City of Richmond
Planning and Development Department

Report to Committee

To: Planning Committee **Date:** April 28, 2011
From: Brian J. Jackson, MCIP **File:** RZ 10-519918
Director of Development
Re: Application by Western St. Albans Venture Ltd. for Rezoning at 7500, 7520,
7540 and 7560 St. Albans Road from Single Detached (RS1/E) to High Density
Townhouse (RTH4)

SITE PLAN
SCALE 1/8" = 1'-0"

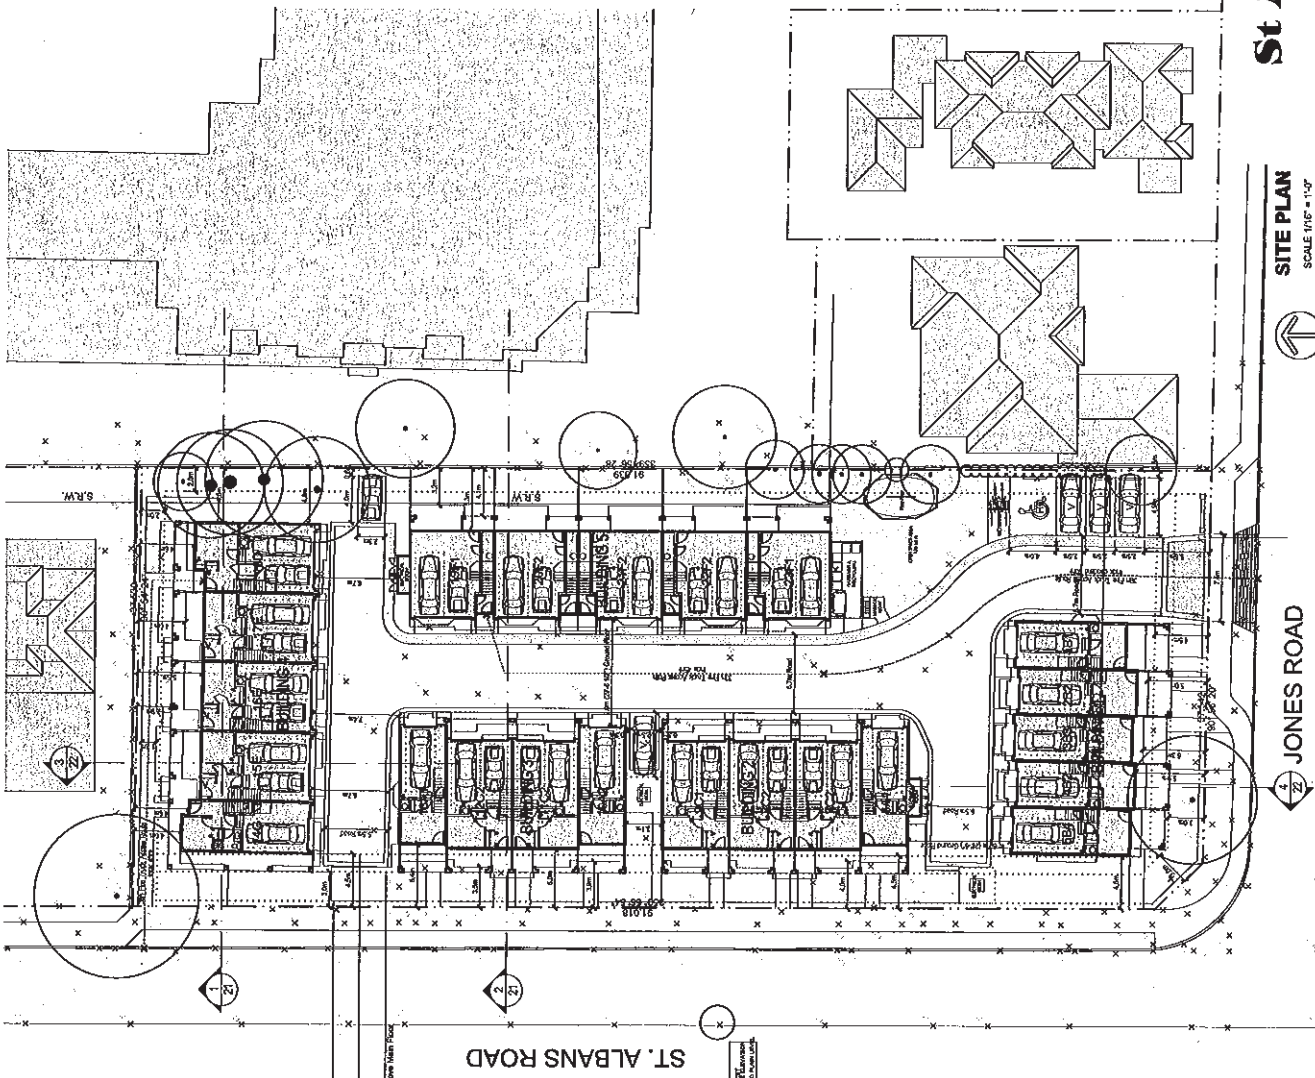
2. Concern that the proximity of the townhouses (and proposed balconies) to the east property line would reduce privacy and sunlight to the existing residential units in the adjacent apartment building to the east.

Looking at the Plans with the proximity of the townhouses and extending balconies to the property line, approximately 5', we are wondering if the balconies could be recessed to give us a little more space, more privacy, and more sunlight. In the surrounding buildings the depth to the lot boundary is much more significant than what is planned on this Site.

Also the ground level of the property, the way it currently sits, is about 3' below street level which, if built at that level, would reduce the height of the building quite substantially again providing more light and feeling of space as was done in the "Palms" at the corner of St. Albans and Granville.

The developer has agreed to build the proposed townhouses along the east property on existing grade and has confirmed that the proposed balconies on the second floor are at a lower elevation than the neighbours' lowest decks.

Based on the review of current site plan for the project, a variance is being requested to reduce the road setback from 4.5 m to a minimum of 3.0 m on all floors above the main floor, including all projections. The proposed building setback with proposed streetscape design (including residential-style entries and windows oriented towards the street and a combination of private outdoor space, trees, shrubs, and decorative fences) is consistent with the Development Permit Guidelines in the City Centre Area Plan for street-oriented dwellings. This variance will be

Drawing Title:
 TREE RETENTION
 PLAN

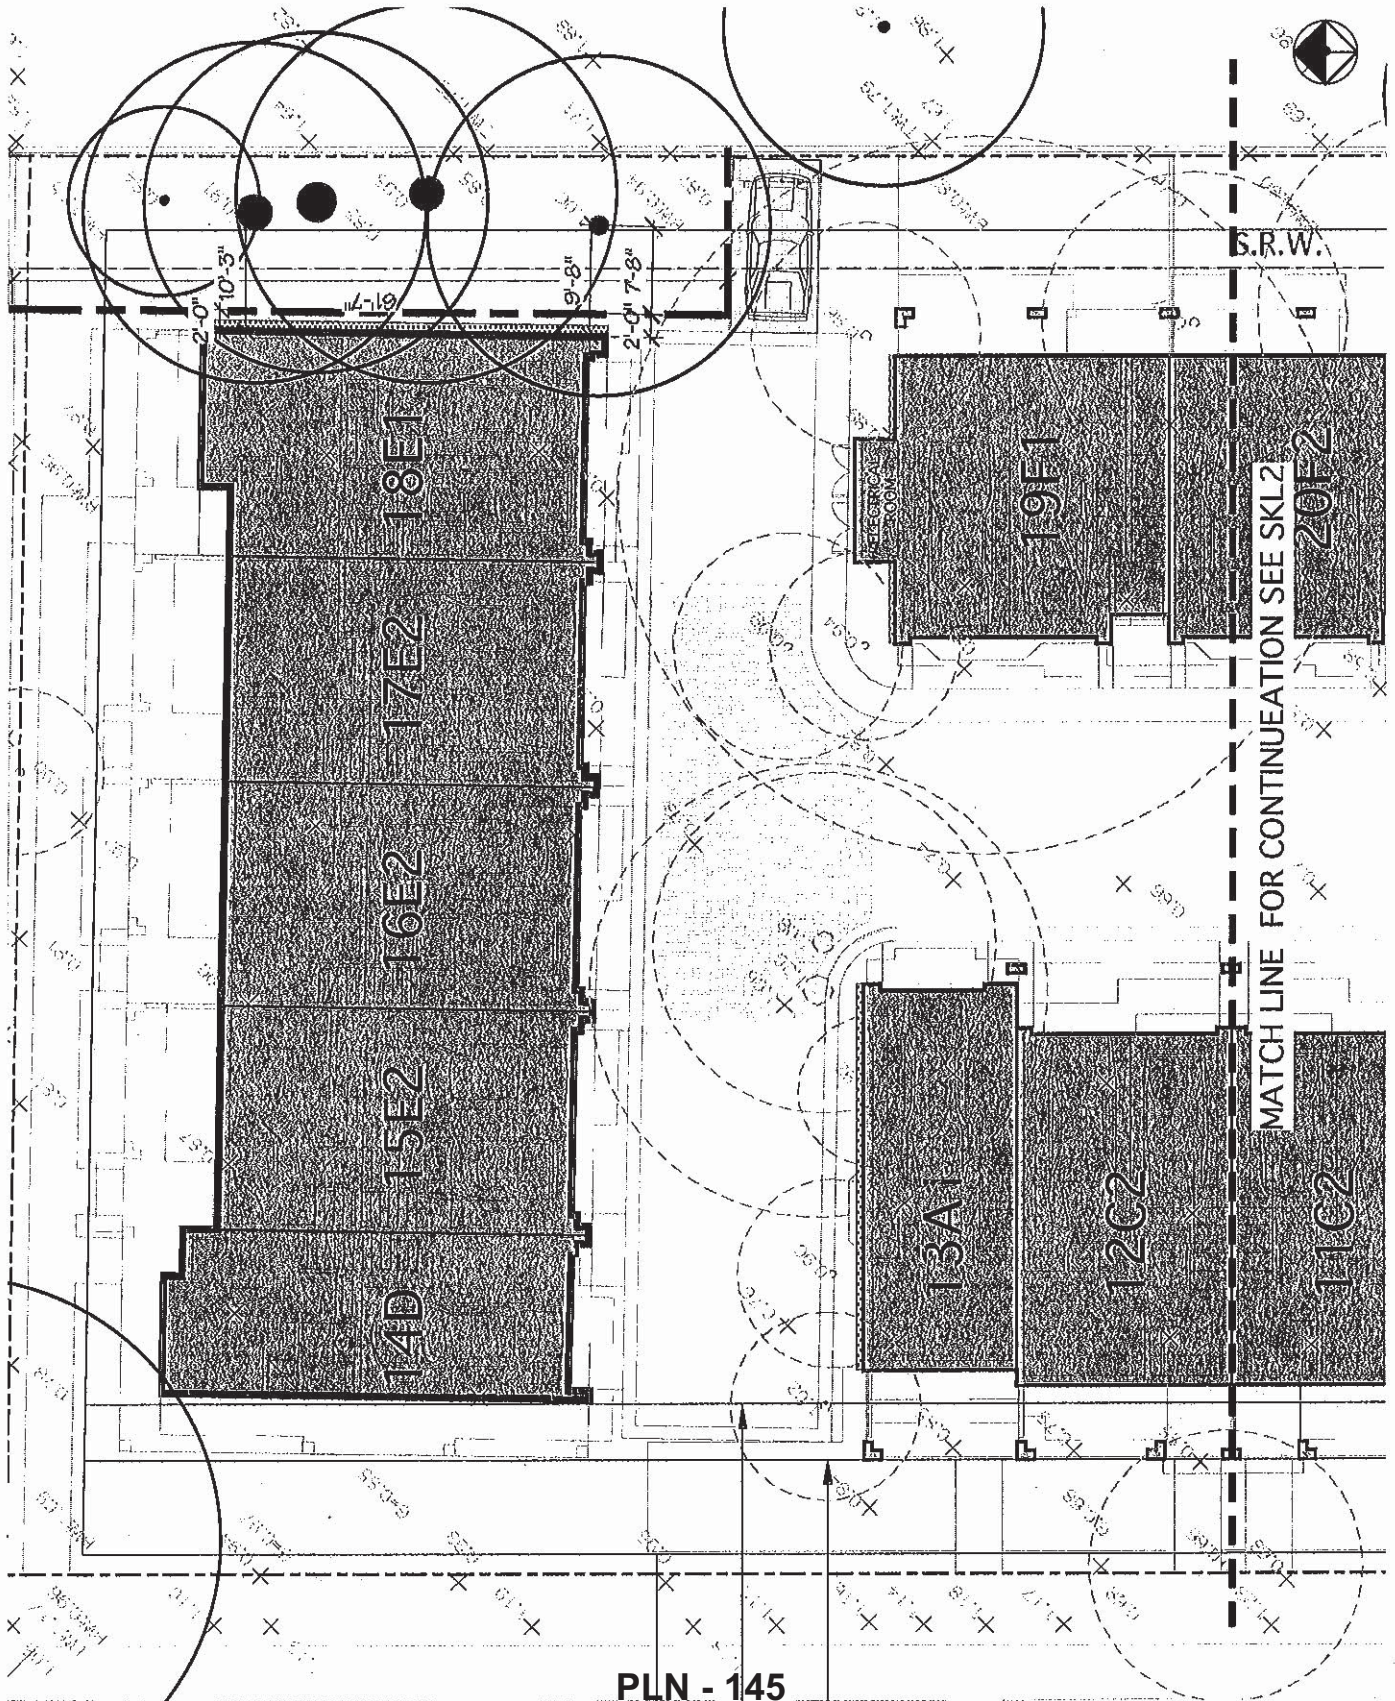
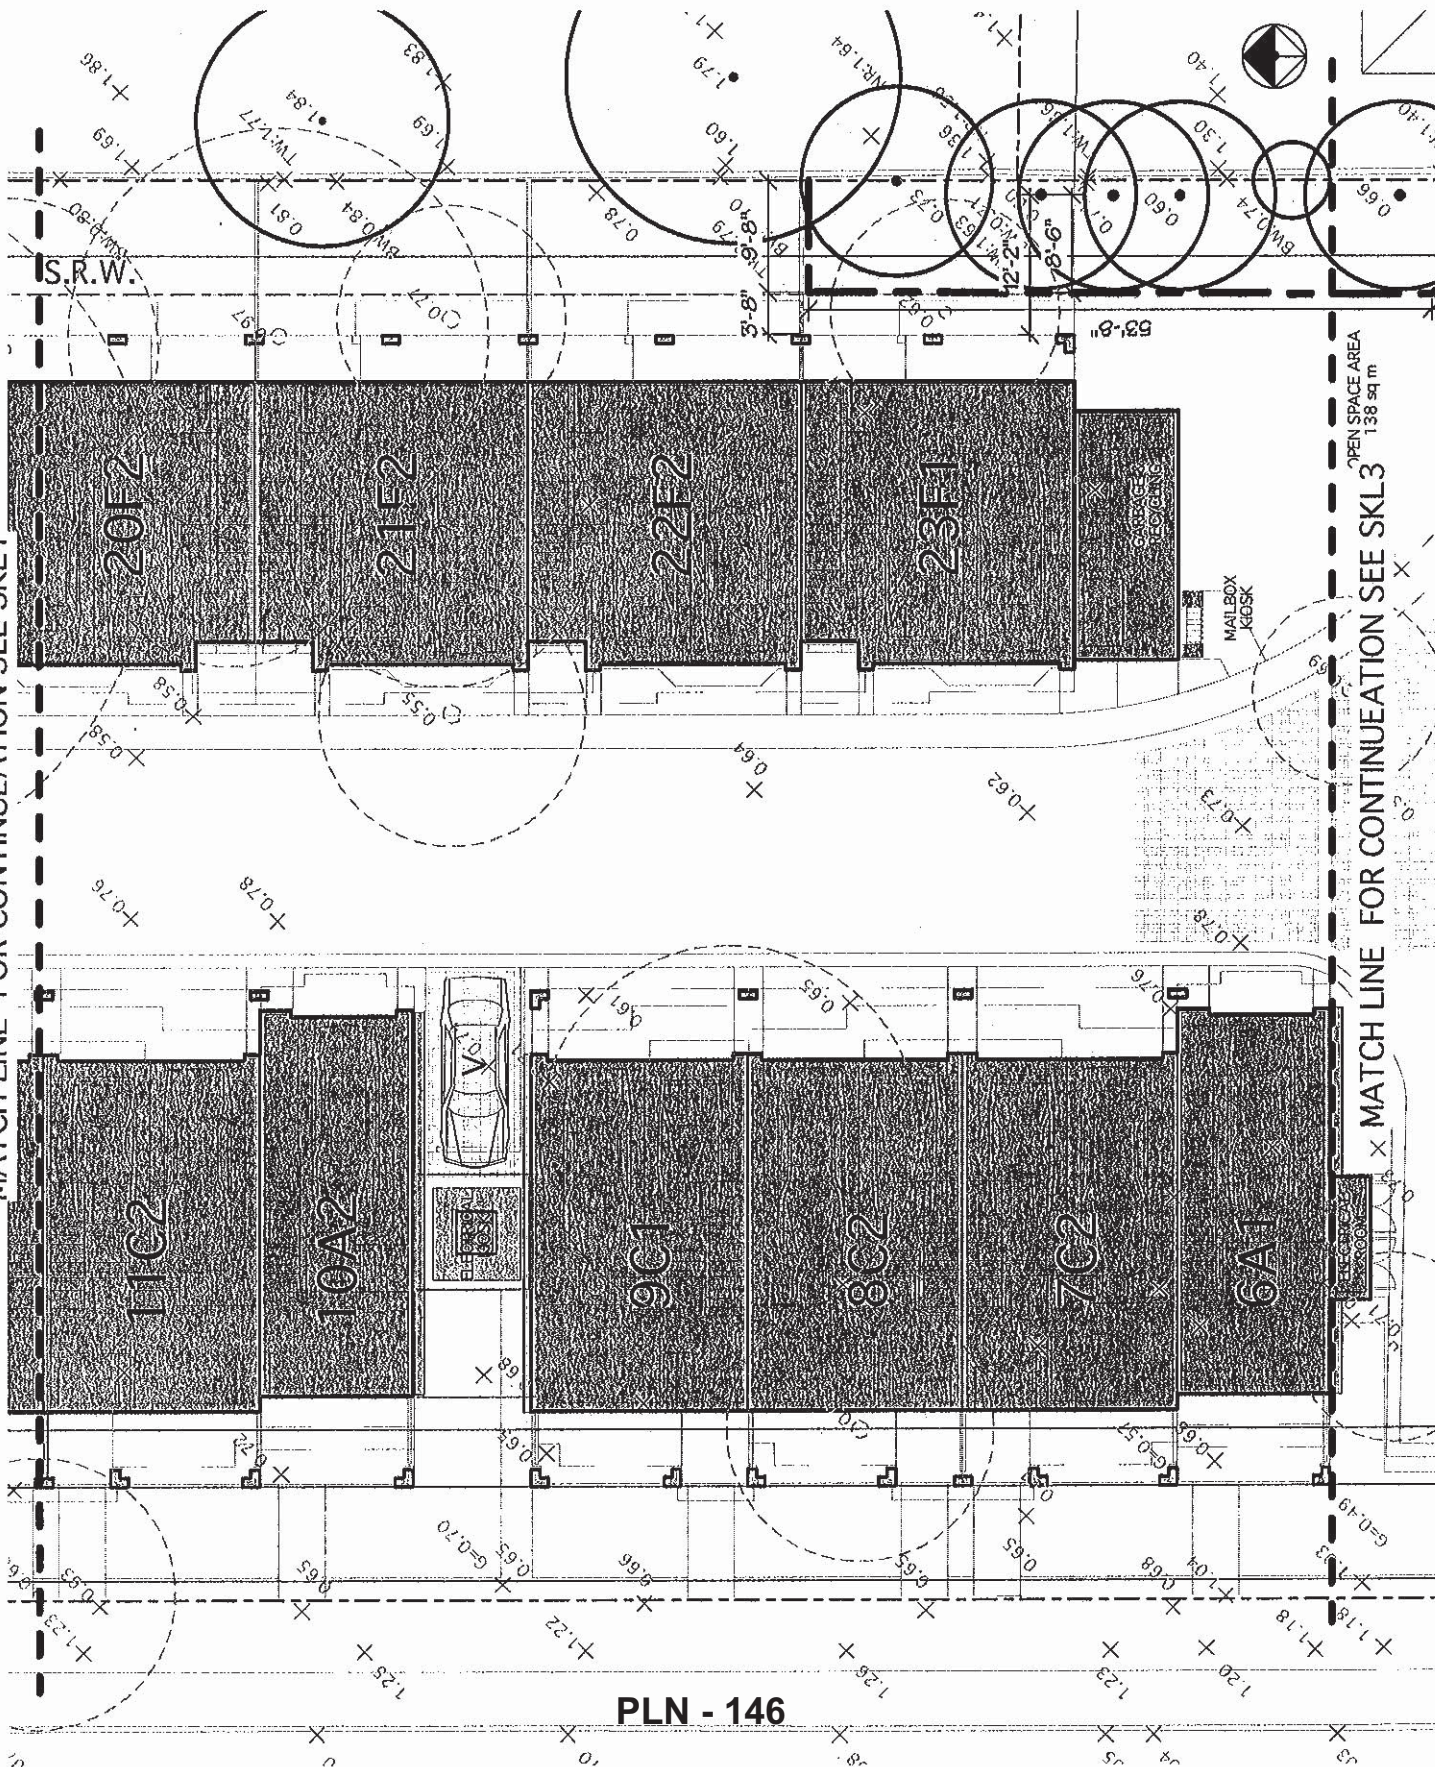
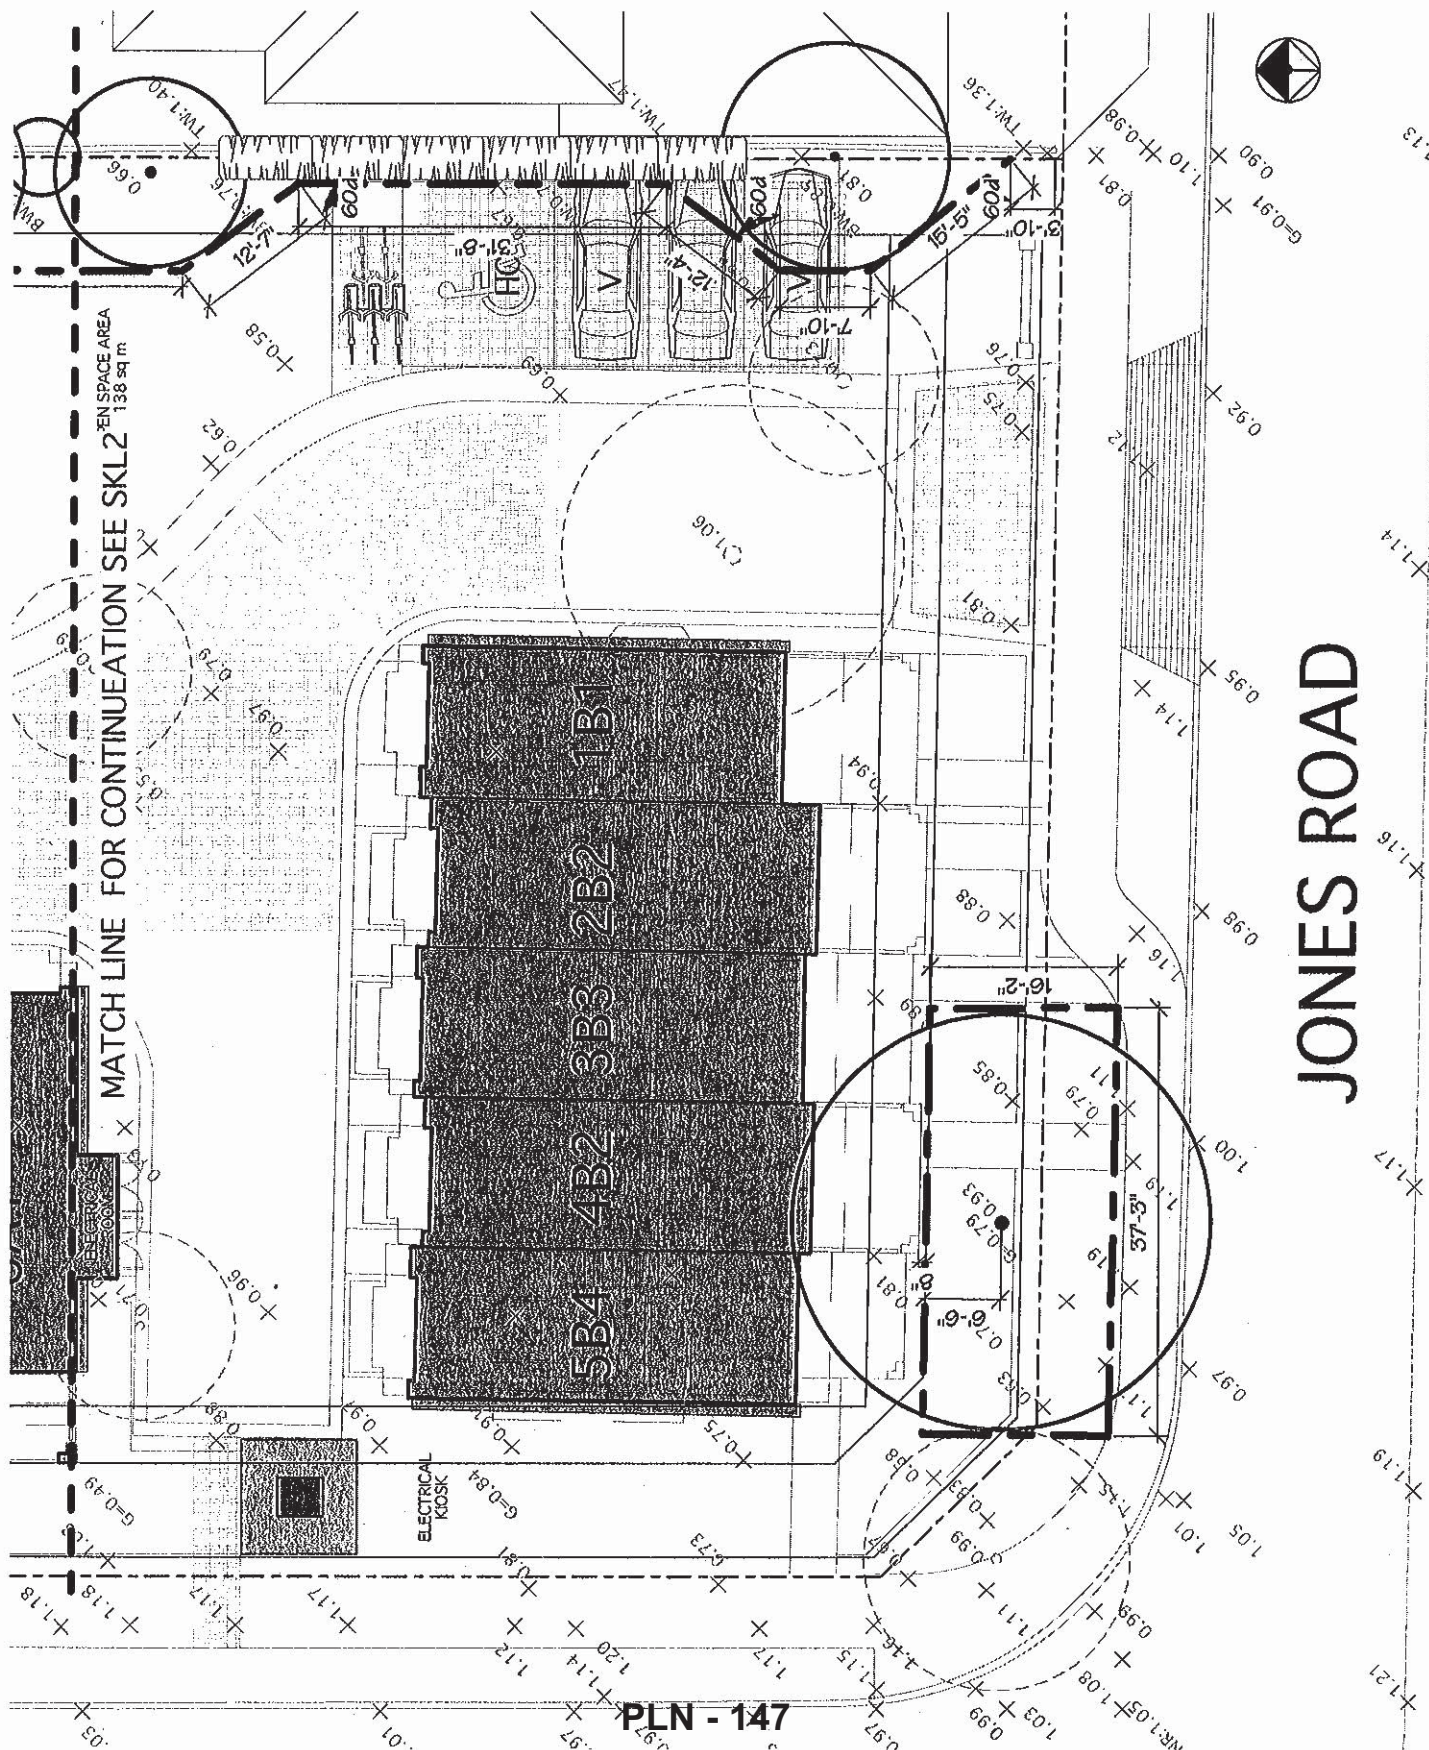
The applicant has committed to the retention of twelve (12) bylaw-sized trees on-site and all of the four (4) trees located on the adjacent properties to the north and east. All of the protected trees are along the east property line, except for a Beech tree located at the southwest corner of the site. The City's Tree Preservation Coordinator has recommended a 3.0 m building setback to the Beech tree. However, it is noted that the proposed setback from the covered porch on the ground floor and the decks on the second and third floor of the B-units fronting Jones Road to the Beech tree is only 2.0 m. In order to protect the Beech tree at the existing location, the project arborist recommended that the second floor deck be supported by small spread footings (and sono tube) off each corner of the deck. This will require only a very minor disturbance to the critical root zone. The project arborist has also recommended a custom designed support system that might involve a wood deck or a suspended slab for the ground level patio under the deck to ensure the site grades between the building and the tree be maintained at the existing elevation. The City's Tree Preservation Coordinator has reviewed and concurred with the project arborist's recommendations. Staff will work with the applicant on the building design to ensure tree protection at the Development Permit stage. A proof of contract with a Certified Arborist for supervision of on-site works conducted close to all protected trees and a tree survival security will be required at the Development Permit stage.

Tree protection fencing on-site around the driplines of all trees to be retained will be required prior to any construction activities, including building demolition, occurring on-site. A Tree Management Plan is attached (**Attachment 6**).

1. Provide a proof of contract with a Certified Arborist for supervision of on-site works conducted close to all protected trees located on site and on adjacent site.
2. Submission of a tree survival security for all protected trees located on site; amount to be determined at the Development Permit stage.

1. Installation of appropriate tree protection fencing on-site around all trees to be retained on site and on adjacent properties to the north and east prior to any construction activities, including building demolition, occurring on-site.
